**Remove oring from radiator 3061-1006**

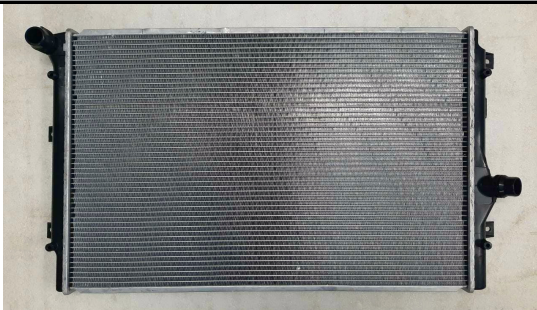
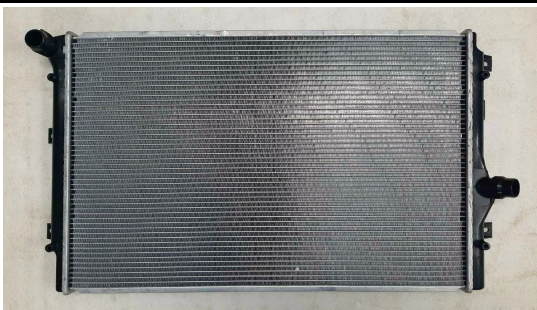
Please note, starting Oktober 2020 we have removed 2 pcs oring from radiator assembly.
The dimension of connection inlet & Outlet pipe slightly bigger than original, so u can use original oring

Reference inlet pipe diameter : 32.3 - 32.53 mm
ADR inlet pipe diameter : 32.4 - 32.65 mm

Reference outlet pipe diameter : 32.38 - 32.49 mm
ADR outlet pipe diameter : 32.42 - 32.5 mm

Previous Condition

with 2 pcs oring

New Condition

without 2 pcs oring
